COMPLAINT AND DEMAND FOR JURY TRIAL

Inspection Report Cement-Based Plaster Stucco Evaluation

The Layne Residence 3894 Marsh Bluff Dr. Jacksonville, FL 32226

8. Issue: The staples are not long enough to properly fasten the lath to the structural framing.

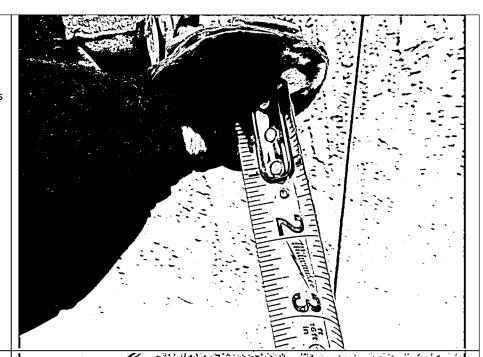
ASTM C-1063 7.10.2.2 (staples). Staples shall have crowns not less than ¾ in. (19.05 mm) and shall engage not less than three strands of lath and penetrate the wood framing members not less than ¾ in (19.05 mm). When metal lath is applied over sheathing, use fasteners that will penetrate the structural members not less than ¾ in. (19

9. Issue: The staples are not long enough to properly fasten the lath to the structural framing.

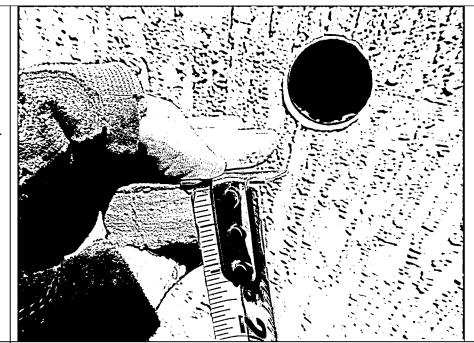
ASTM C-1063 7.10.2.2 (staples). Staples shall have crowns not less than ¾ in. (19.05 mm) and shall engage not less than three strands of lath and penetrate the wood framing members not less than ¾ in (19.05 mm). When metal lath is applied over sheathing, use fasteners that will penetrate the structural members not less than ¾ in. (19 mm).

11. Issue: The stucco does not meet the thickness required by the standards.

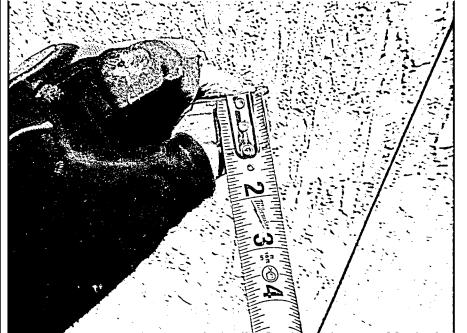
ASTM C 926 Table 4 - Nominal Plaster Thickness - per Table 4, the minimum thickness of stucco installed with metal base over solid base is a 7/8" 3 coat system.

12. Issue: The stucco does not meet the thickness required by the standards.

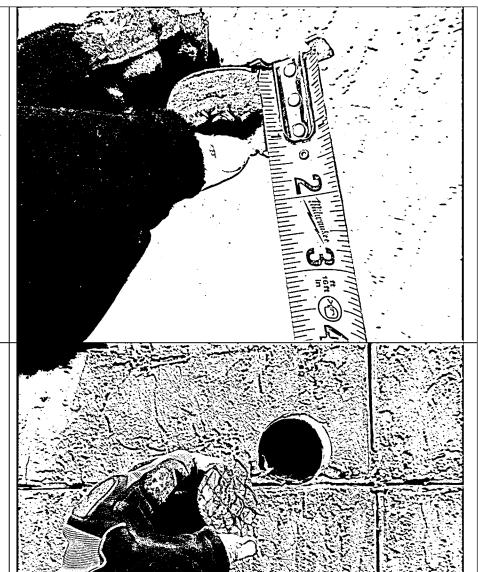
ASTM C 926 Table 4 - Nominal Plaster Thickness - per Table 4, the minimum thickness of stucco installed with metal base over solid base is a 7/8" 3 coat system.

13. Issue: The stucco is not embedded fully into the lath.

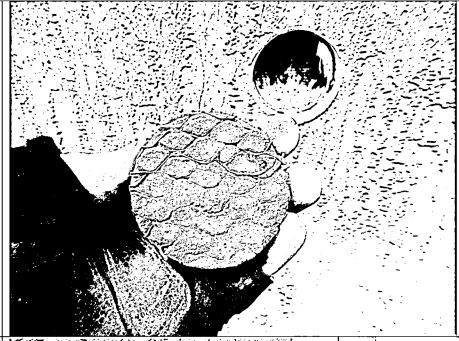
ASTM C926 7.2.1 - (Embedment)
The first (scratch) coat shall be
applied with sufficient material
and pressure to form full keys
through, and to embed the metal
base, and with sufficient
thickness of material over the
metal to allow for scoring the
surface.

16. Issue: Dissimilar materials must be separated to allow for expansion and contraction.

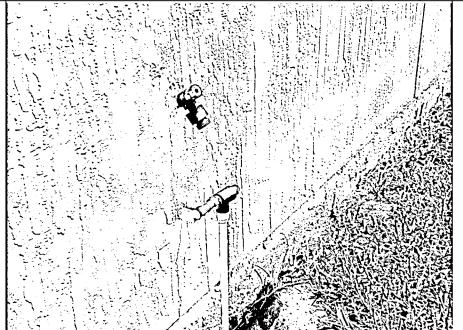
ASTM C 926 7 .1 .4 (Dissimilar Materials) Separation shall be provided where plaster abuts dissimilar construction materials or openings.

ASTM C-1063 7.11.3 (dissimilar material)—Nonload-bearing members shall be isolated from load-bearing members, and all penetrating elements, with casing beads or other suitable means, to avoid transfer of structural loads, and to separate from dissimilar materials

18. Issue: Dissimilar materials must be separated to allow for expansion and contraction.

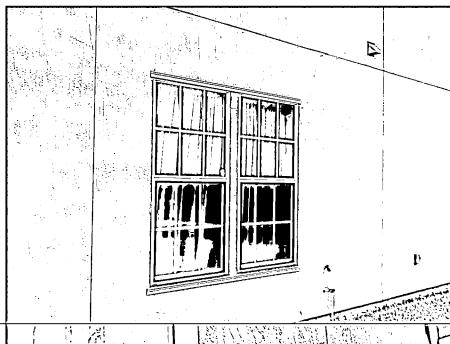
ASTM C 926 7 .1 .4 (Dissimilar Materials) Separation shall be provided where plaster abuts dissimilar construction materials or openings.

ASTM C-1063 7.11.3 (dissimilar material)—Nonload-bearing members shall be isolated from load-bearing members, and all penetrating elements, with casing beads or other suitable means, to avoid transfer of structural loads, and to separate from dissimilar materials

19. Issue: Dissimilar materials must be separated to allow for expansion and contraction.

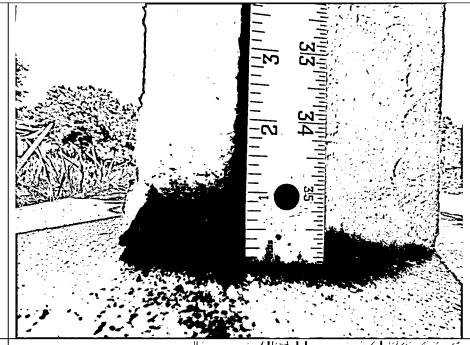
ASTM C 926 7.1.4 (Dissimilar Materials) Separation shall be provided where plaster abuts dissimilar construction materials or openings.

ASTM C-1063 7.11.3 (dissimilar material)—Non-load-bearing members shall be isolated from load-bearing members, and all penetrating elements, with casing beads or other suitable means, to avoid transfer of structural loads, and to separate from dissimilar materials

21. Issue: A weeping accessory must be present at any horizontal and vertical intersection to allow moisture to exit.

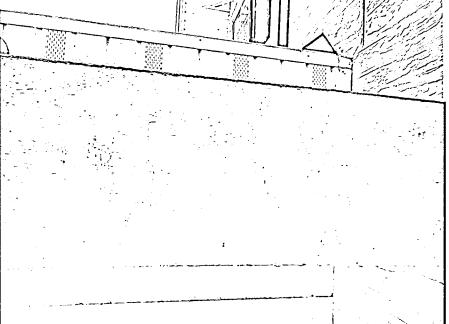
ASTM C 926 section A2.2.3 states: (horizontal and vertical intersection) - Where vertical and horizontal exterior plaster surfaces meet, both surfaces shall be terminated with casing beads with the vertical surface extending at least ¼ in. (6 mm) below the intersecting horizontal plastered surface, thus providing a drip edge. The casing bead for the horizontal surface shall be terminated not less than ¼ in. from the back of the vertical surface to provide drainage.

22. Issue: A weeping accessory must be present at any horizontal and vertical intersection to allow moisture to exit.

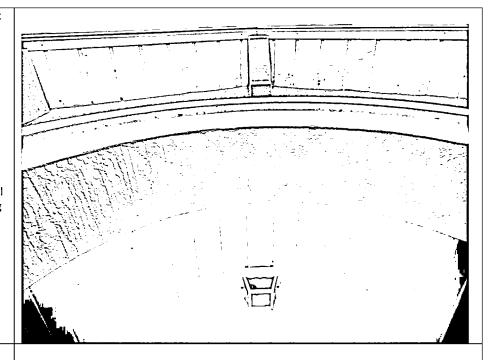
ASTM C 926 section A2.2.3 states: (horizontal and vertical intersection) - Where vertical and horizontal exterior plaster surfaces meet, both surfaces shall be terminated with casing beads with the vertical surface extending at least ¼ in. (6 mm) below the intersecting horizontal plastered surface, thus providing a drip edge. The casing bead for the horizontal surface shall be terminated not less than ¼ in. from the back of the vertical surface to provide drainage.
